# Rusnak Pasadena Volvo Predevelopment Plan Review

January 10, 2022

# PPR Comments

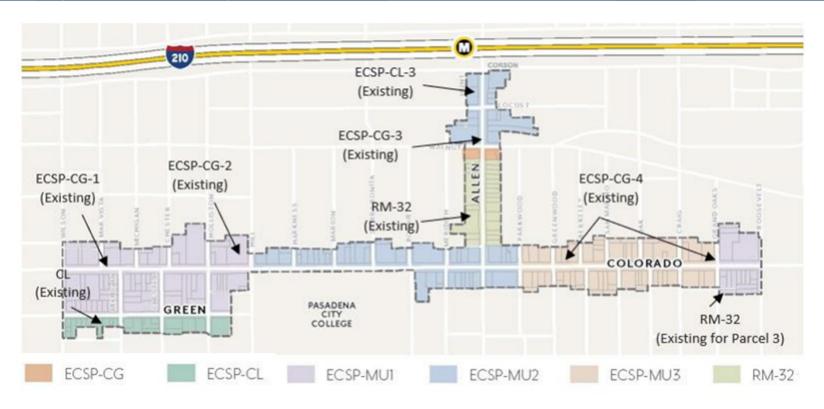
The project does not comply with the following key development standards in the Zoning Code:

Standard	Requirement	Proposed
Use	Mixed-Use and Multifamily uses not allowed in ECSP-CG-4 zone	Mixed-Use
Density	Not applicable in ECSP-CG-4; 4 units allowed on RM-32-PK site	193 units
Floor Area	No FAR specified in Zoning Code, however General Plan Low Mixed-Use designation allows up to 1.0 FAR	1.85 FAR
Height	ECSP-CG-4: 45 feet RM-32-PK: 32 feet (to ridgeline), 23 feet (to top plate)	40 feet (complies with ECSP-CG-4, does not comply with RM-32-PK)
